# **Code Maintenance 2001**

## **City Council Adopted Report (Ordinance # 175966)**

**City of Portland  
Office of Planning and Development Review  
Land Use Review Division**

**Date Adopted: September 26, 2001  
Amendments Effective: October 26, 2001,**

**Figure 120-1**  
**Alteration to Existing Building in Conformance with Maximum Setback Standard**

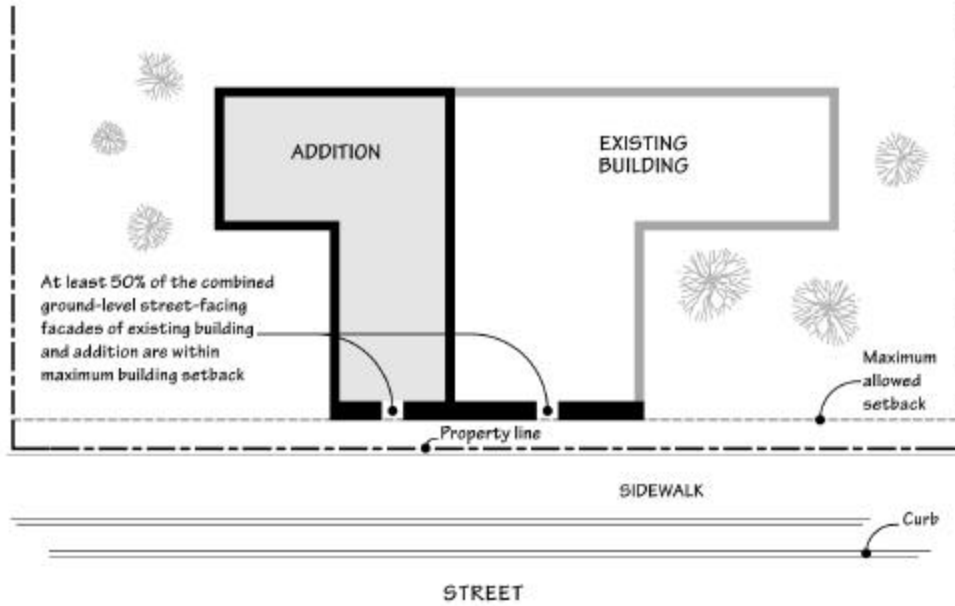
Additionally, it is not clear from existing Code language how to apply the maximum transit street setback standard when constructing an addition to the rear of an existing building that currently does not meet the maximum transit street setback. Because the maximum transit street setback applies only to street-facing facades, if the addition is constructed entirely to the rear of the existing building, the addition has no façade that is visible from the street and, therefore, is not subject to the maximum transit street setback. The adopted amendment clarifies this by adding new text and by including additional graphics.

The adopted amendment also clarifies (through new text and graphics) how to measure the length of ground level, street-facing facade required to be within the maximum setback when there are multiple buildings on the site. The intent of this regulation is to place at least 50 percent of the cumulative ground level building walls close to the sidewalk. This allows a rational development of deep lots, whereby at least half of the *cumulative* length of ground level, street-facing building walls is within 25 feet of the curb, while the remainder of the street-facing walls may be placed at a greater distance from the curb.

- (4) Where an existing building that meets the standard of this paragraph is being altered, the standard of this paragraph applies to the ground level, street-facing façade of the entire building. Where the existing building does not meet the standard of this paragraph, see Section 33.258.070.C. See Figures 120-1 and 120-2.

**Figure 515-1  
(adopted)**

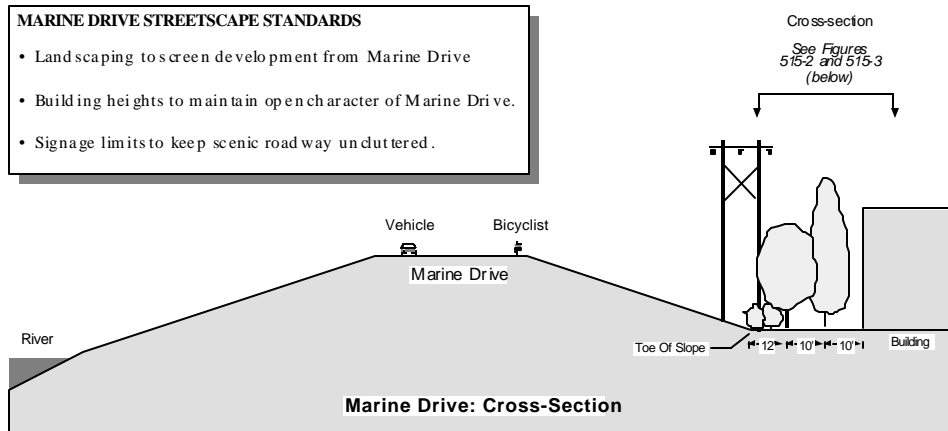
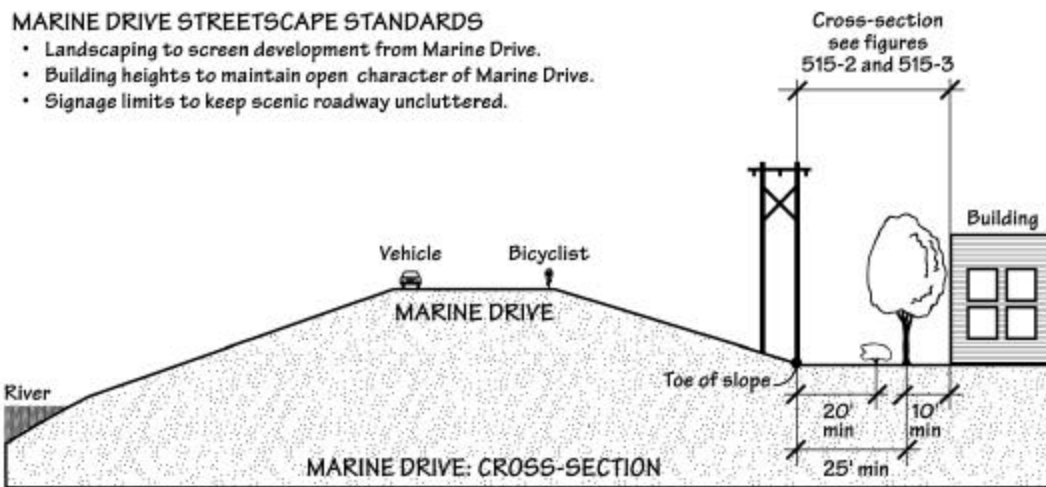
Consistent with the cited federal guidelines and Multnomah County Drainage District No. 1 standards, the adopted amendment modifies the existing landscape standard so that the root zone of required trees and shrubs do not encroach within 15 feet of the toe of the Marine Drive slope. Existing standards require a double row of trees, planted a maximum of 15 feet on-center, with ten feet of spacing between the two tree rows. (The species of tree required for the northern row have a larger, round canopy, while the species of tree required for the southern row have a columnar canopy.) The amendment will require only a single row of trees, of the same spacing and species as presently required for the northern tree row. A single row of trees of the species identified, planted a maximum of 15 feet on center, will equally meet the legislative intent of the Marine Drive landscape requirement by providing a dense, living buffer between the industrial development and Marine Drive.

The alternative option of merely increasing the minimum distance between the double row of trees and the toe of the slope would require a landscape buffer 45 feet in depth, a 40 percent increase in depth over that required by existing standards. This was deemed to be a substantial policy change that is beyond Code Maintenance 2001. By contrast, the adopted amendment will result in only a three foot increase in the overall depth of the landscape buffer.

**Figure 515-4**  
**Clustered Landscaping Example**  
**(Adopted)**

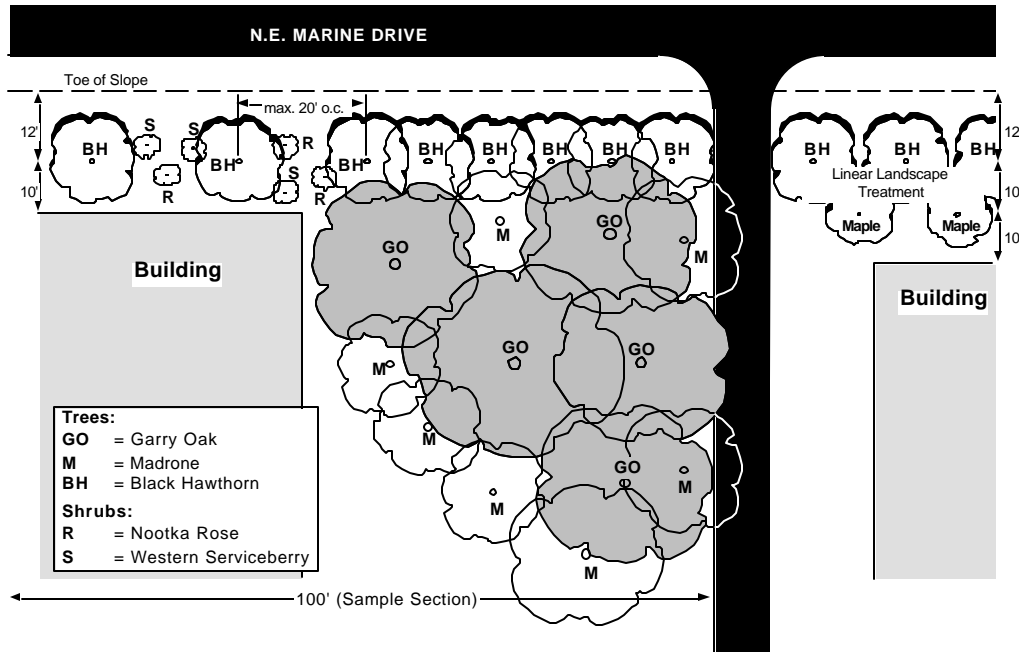
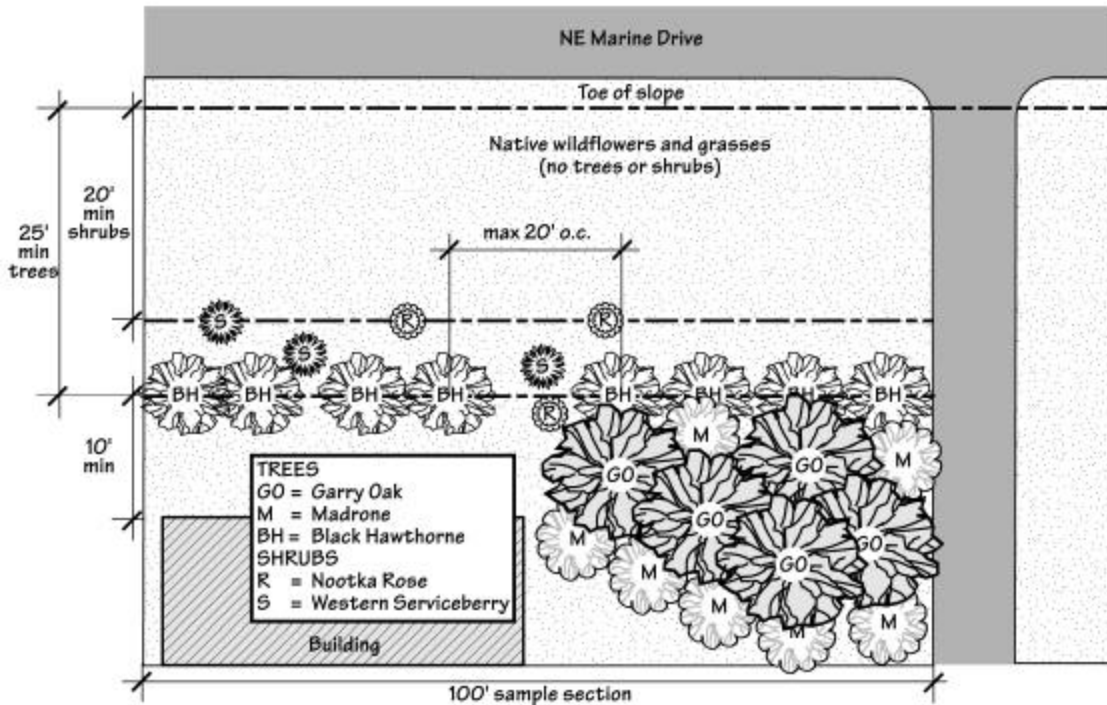
The amendment also includes a reorganization of the Marine Drive landscape standards. The purpose for this reorganization is to improve the clarity of the text, and to facilitate its implementation. With one exception, this reorganization results in no substantive change to existing regulations. The one exception is new language (33.515.215.E.3) that clarifies the perimeter landscape requirement for parking lots and exterior storage areas on sites in the entryway locations along Marine Drive.

4. Entryway locations along Marine Drive. At two entryway locations along Marine Drive, the applicant may choose to meet either the standards of Paragraphs D.1 through D.3, above, or the alternative standards of this paragraph. The entryway locations are between Interstate 205 and NE 122nd Avenue, and between NE 174th Avenue and NE 185th Avenue. The alternative standards, as shown in Figure 515-4, are:

- c. Location. Trees must be at least 25 feet from the toe of the Marine Drive slope. Shrubs must be at least 20 feet from the toe of the Marine Drive slope.
